M E M O R A N D U M
December 2, 2015

TO: Landmarks Board

SUBJECT: Public hearing and consideration of a Landmark Alteration Certificate application to demolish an existing house built in 1957 and, in its place, construct a new 2,500 sq. ft. house at 2110 4th Street in the Mapleton Hill Historic District, per section 9-11-18 of the Boulder Revised Code (HIS2015-00254).

Figure 14. Proposed Site Plan

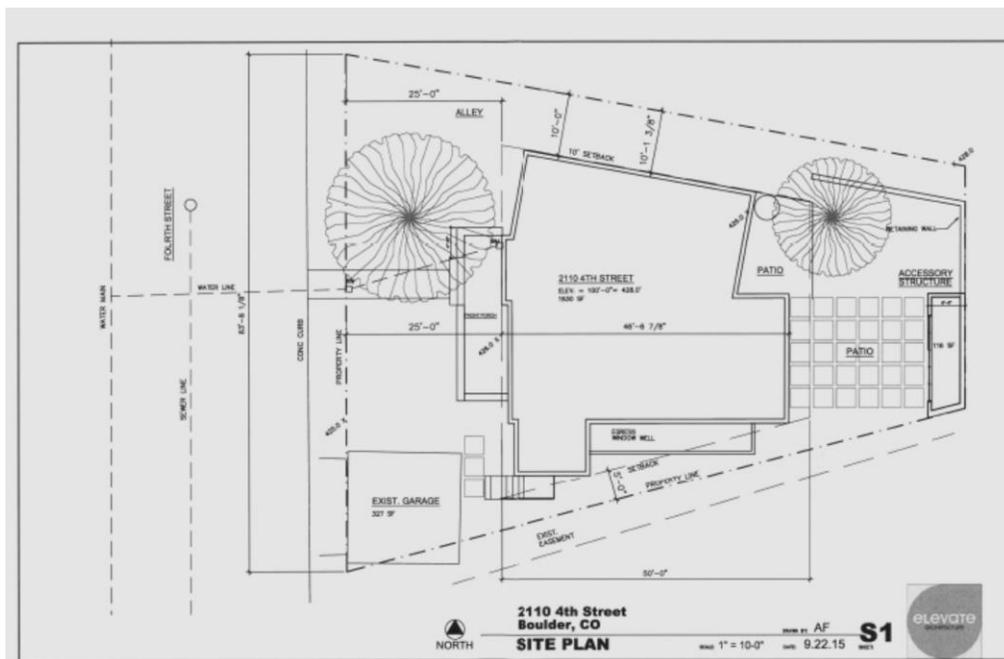
In plan, the proposed new house is shown to be located at approximately the same location as the existing house. The existing house is located approximately 26' from the west property line and the proposed house is shown to be located at the 25' front yard setback. The existing house measures approximately 35' wide and 26' long, with a 21'

by 8' shed-roof portion located at the rear of the house. The proposed house is shown to measure 46'-6" long and approximately 50' wide with the north wall creating an oblique angle running parallel to the north property. Currently the alley provides access to at least one property to the east. The existing contributing garage is shown to be maintained in its current location.

The site plan indicates construction of rear retaining walls, a rear patio and a 116 sq. ft. accessory building, (no elevations provided). No information was provided as to whether any changes to the contributing garage are contemplated as part of this project.

<i>General Design Guidelines</i>			
2.0 Site Design			
<p>Site design includes a variety of character-defining elements of our historic districts and building. Individual structures are located within a framework of streets and public spaces that set the context for the neighborhood. How structures occupy their site, in terms of alignment, orientation, and spacing, creates much of the context of the neighborhood.</p>			
	<i>Guideline</i>	<i>Analysis</i>	<i>Conforms?</i>
.1	<i>Locate structures within the range of alignments as seen traditionally in the area, maintaining traditional setbacks at the front, side and rear of the property</i>	<p>The property measures 67’ wide, creating a shallow triangular shape where the typical building pattern in Mapleton Hill is 50’ wide by 100’ deep rectangular form. The building is proposed to have a similar front yard setback as the existing house, and is shown to be 11 ft. wider than the existing house and contained within the front, rear and side yard setback standards. This section of 4th Street in Mapleton Hill does contain a number of historic houses with alignments similar to that proposed. However, north portion of house at oblique angle to the rest of the house and not perpendicular to 4th Street as is historic pattern in Mapleton Hill. This condition will be visible from 4th Street and possibly Mountain View Drive. Redesign house to be</p>	No

parallel and perpendicular to 4 th Street.	
.2	<i>Building proportions should respect traditional patterns in the district</i>	The proposed house is comprised of three vertically-proportioned forms and one cubic form as viewed from the street. Truncated gable form as viewed from the northwest and multiple level flat roof forms appear inconsistent with historic character of the district. Traditional building proportions are typically simpler in form, not dominated by flat roofs and don't include oblique angles as shown (see .1 above). Roof of first story of south cubic form intersects with wall of upper stories of two north volumes on façade. Consider combining forms to reflect traditional building proportions more reflective of those historically found in the district and immediate streetscape.	No
.3	<i>Orient the primary building entrance to the street</i>	Primary entrance is oriented to the street.	Yes
